21 January 2022

Structural Condition Assessment - Annex  
Captain Thomas Thompson House  
179 Pleasant Street  
Portsmouth, New Hampshire

HDC WORK SESSION #2 APPLICATION TO AMEND PREVIOUS APPROVAL: FEBRUARY 2, 2022

1  
SK

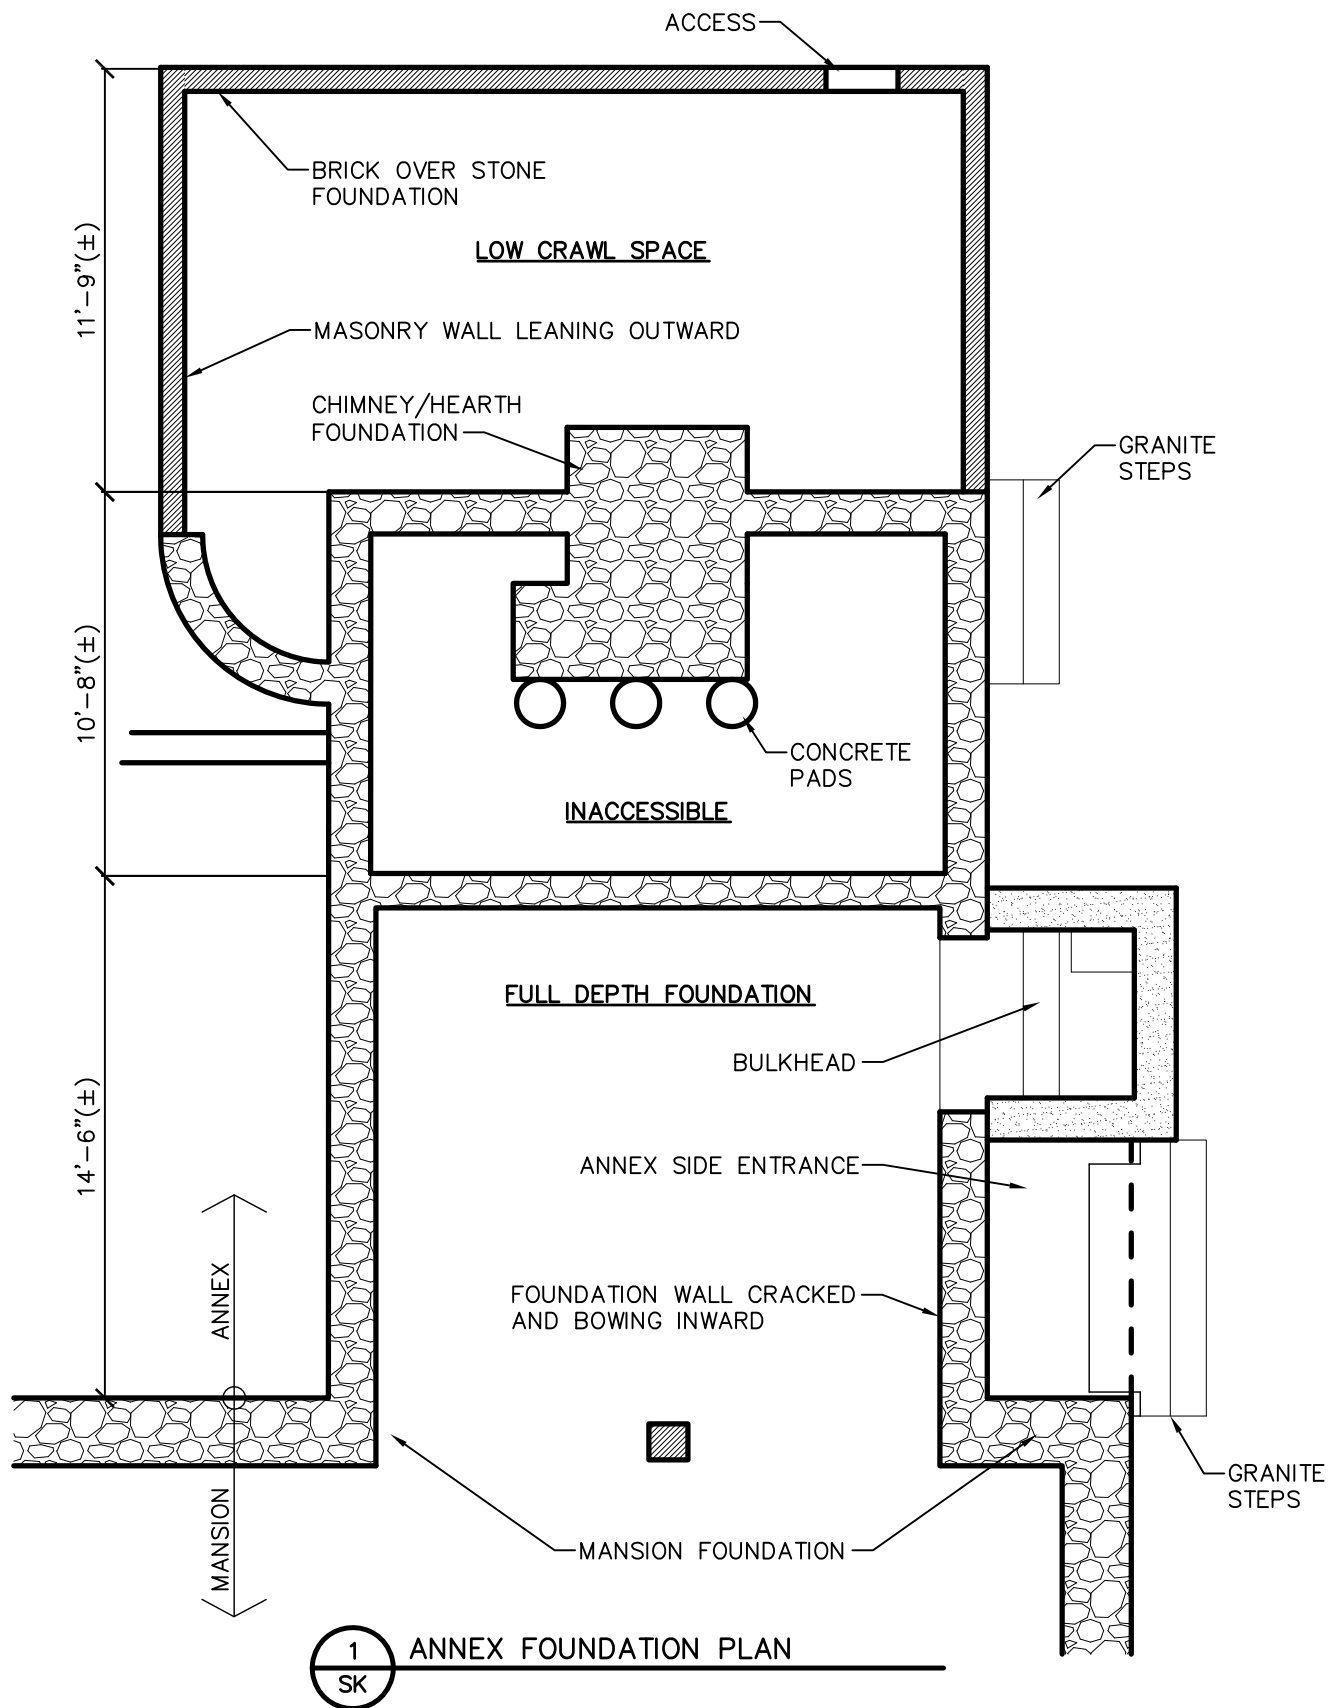
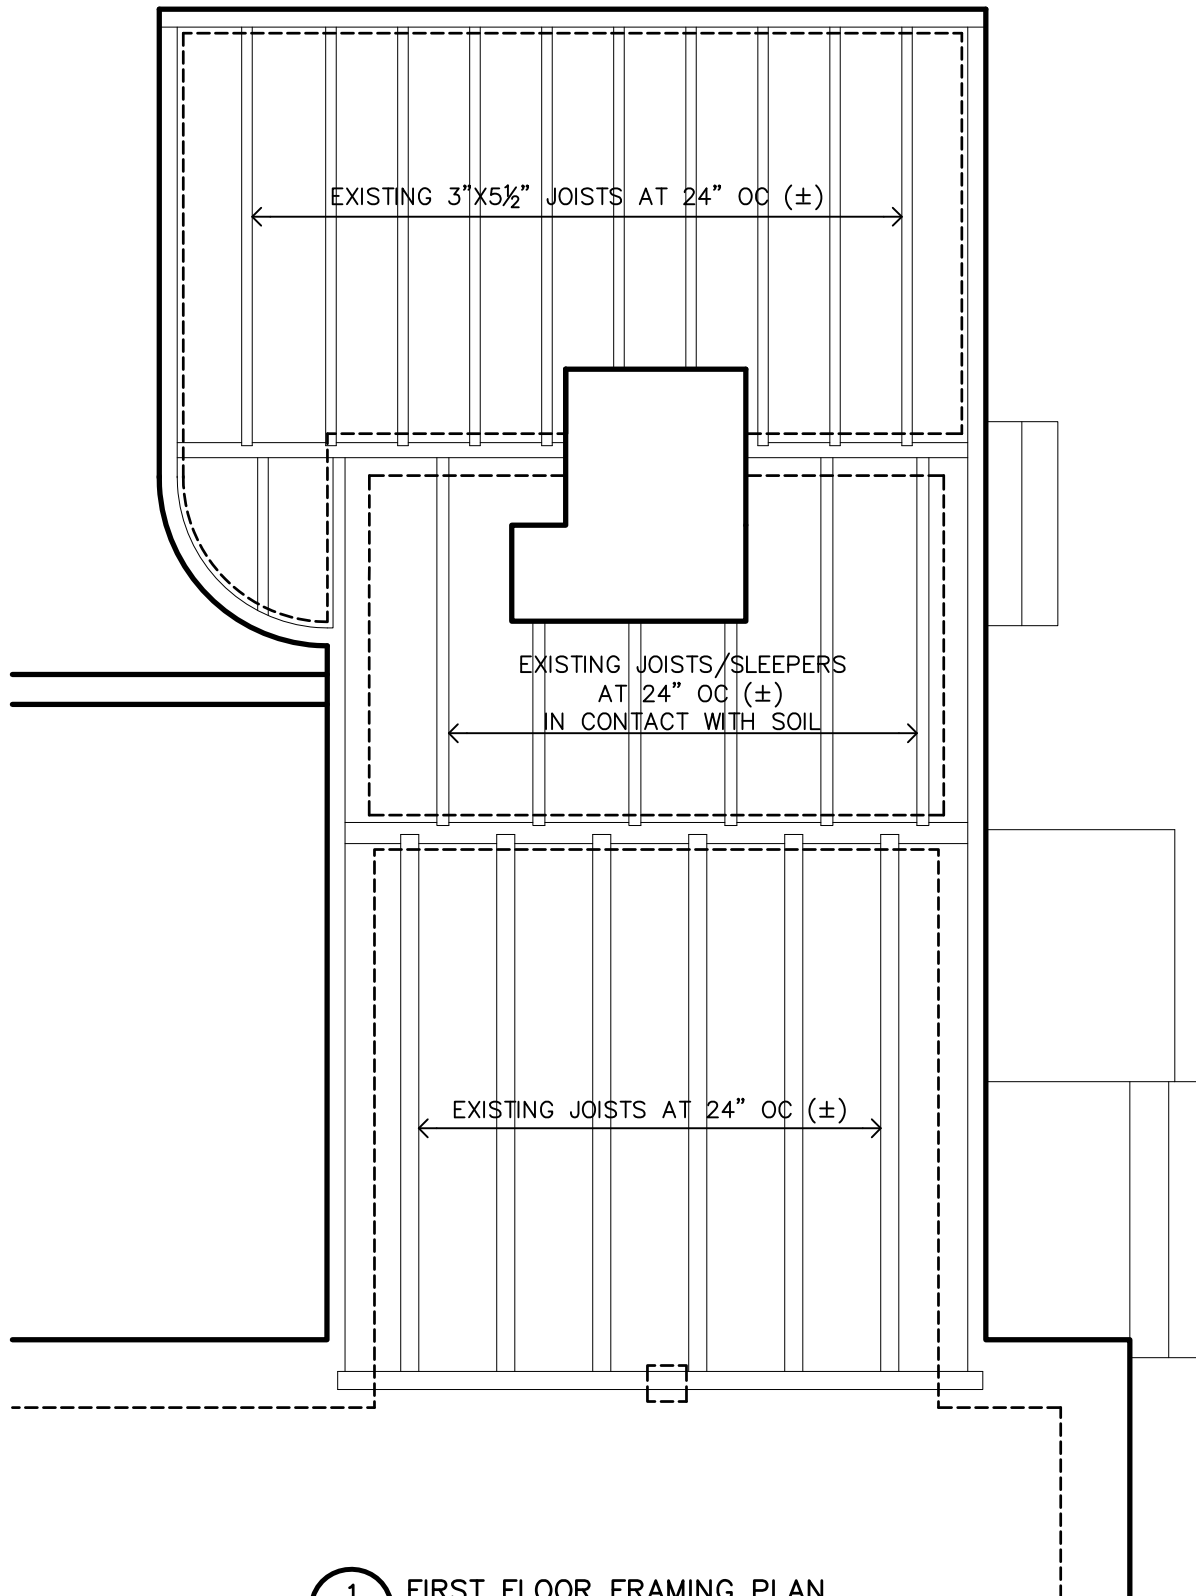
The annex is supported a combination of brick and stone foundations with three distinctly different areas. See SK1 attached. From the back wall of the mansion, a full depth stone foundation extends east 14'-6" ( $\pm$ ). The next area is inaccessible with a shallow stone perimeter foundation wall and an exposed earth floor extending east 10'-8" ( $\pm$ ). The third foundation area is constructed of brick over stone masonry perimeter wall enclosing a low clearance crawl space with an exposed earth floor extending east 11'-9" ( $\pm$ ).

The full-height stone foundation wall along the side entrance appears to be bowing inward with numerous cracks in the mortar joints. This is most likely due to the surcharge force

from the side entrance foundation, which is in visibly poor condition and in need of repair or replacement. Further investigation of this area is recommended.

The brick and stone foundation is in poor condition with eroded mortar joints and some wall areas visibly leaning out of plumb. My opinion is that the crawl space foundations will require significant repair.

The annex first floor framing is a combination of heavy timber, wood framing in direct contact with soil, and timber joists over a crawl space. See SK2 attached. My opinion is that the first floor framing, over the crawl space areas, is in poor condition and may need to be removed to provide access to the crawl space so the foundation can be repaired, for the installation of a proper vapor barrier, and to install new MEP systems.
